Product Change Notification

Product Group: DR/Fri May 31, 2024/PCN-DR-00005-2024-REV-0

CMF Industrial CMF50, CMF55, CMF60, CMF65, CMF07, and CMF20.

DIMENSIONS in millimeters

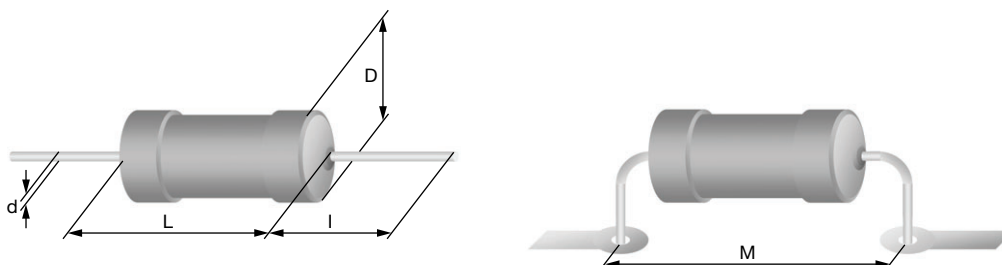
GLOBAL MODEL	D _{max.}	L _{max.}	d _{nom.}	I _{min.}	M _{min.}	MASS (mg)
CMF50	1.6	3.6	0.5	29	5	125
CMF55	2.5	6.5	0.6	28	10	220
CMF60	4.2	11.9	0.8	31	15	700
CMF07	2.5	6.5	0.6	28	10	220
CMF20	4.2	11.9	0.8	31	15	700

DERATING

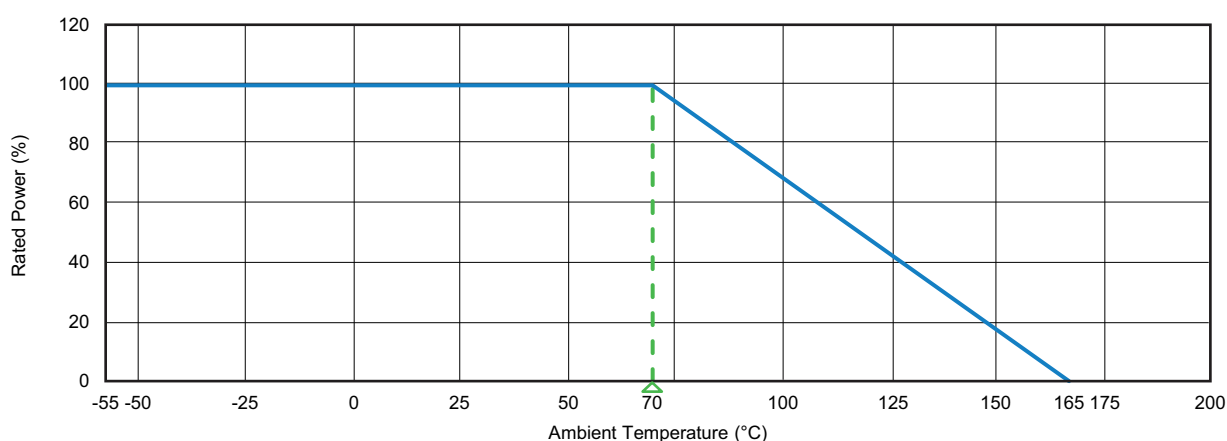
The power rating for the CMF parts is tied to the derating temperature, the heat rise of the parts, and the ΔR for the load life performance. When the tables/graphs below are used together they show that when the parts are run at their higher power ratings, the parts will run hotter, which has the potential of causing the resistance of the parts to shift more over the life of the part.

CMF resistors have an operating temperature range of -55 °C to +125 °C. They must be derated at high ambient temperatures according to the derating curve.
